Technical Note Title

Location	2-14 Tennyson Road
Application for	Planning Proposal for a mixed residential, retail and aged care development

Bitzios Consulting has been commissioned by the City of Ryde as an independent reviewer of the planning proposal for a mixed use development at the above address. This technical document summarises our review of the traffic aspects of the planning proposal.

Figure 4.1: Traffic Report Figure 8 Existing PM Peak

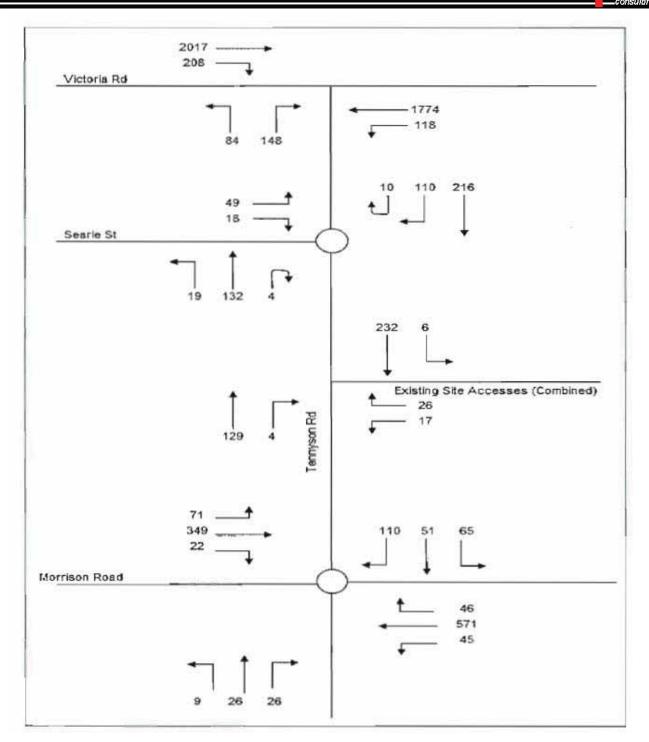
Evening Peak Traffic Data was presented Figure 8 of the report (see Figure 4.1). The volumes surveyed appear to be reasonable. No date or source was provided for the traffic surveys. Without further evidence from where the data was sourced it is assumed that the data was accurately surveyed. Further, traffic data supplied by Council indicates that the traffic volumes are reasonably consistent with counts from November 2012.

The report suggests that the existing access was surveyed (see Section 3.6 of the Traffix report). The data (Figure 8) shows almost exactly 60% to and from Victoria Road and 40% to and from Morrison Road, as well as a split of 80% from the site and 20% to the site. It is noted that these values are used consistently in the study.
